VENTANA OAKS  
PRELIMINARY OVERALL AREA DEVELOPMENT PLAN  
SAN ANTONIO, TEXAS

SHEET NO. 1  
OF 1 SHEETS  
FILE NO. 01031  
POADP1.DWG

## POADP APPLICATION

# REQUEST FOR REVIEW of POADP

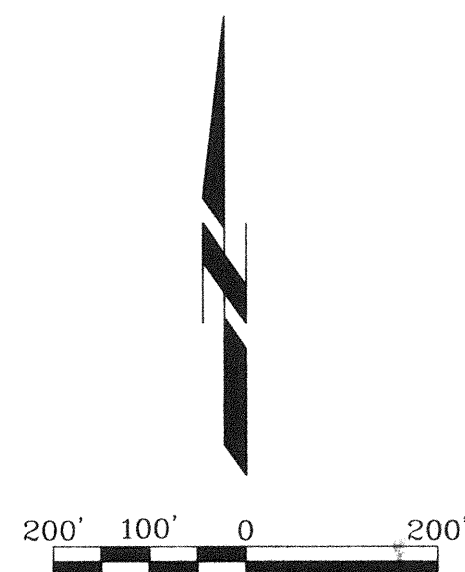
For residential development directly adjacent to State ROW, the developer shall be responsible for adequate set-back and/or sound abatement.

Access to US 281 will be as directed by "Regulations For Access Driveways to State Highways". This property is eligible for a maximum combined total of one access point. All access to the property identified as "Tract 1 Commercial" and "Tract 2 Commercial" shall be from proposed Ventana Parkway.

At the time of platting a complete copy of the approved WPAP will be required. No access permits will be issued prior to receipt of the approved WPAP..

A TIA IS REQUIRED

Comments: Need 70' collectors, instead of the 60' row.

Zone B-3 - proposed uses  
are commercial - complies  
with adjacent POADP

Comments: HARDY OAKS IS ON THE MTP REQUIRING A MIN.  
OF 80' ROW. PROPOSE POADP DOES NOT ADDRESS THOROUGHFARE  
U.S. 281 IS ON THE MTP AND TXDOT SYSTEM REQUIRING  
A MIN. OF 110' ROW AND TXDOT RELEASE

- Coordinate tree preservation
- Provide linkage to 100 yr flood plain for pedestrian neighborhood as greenbelt recommended
- free homes to greenbelt recommended
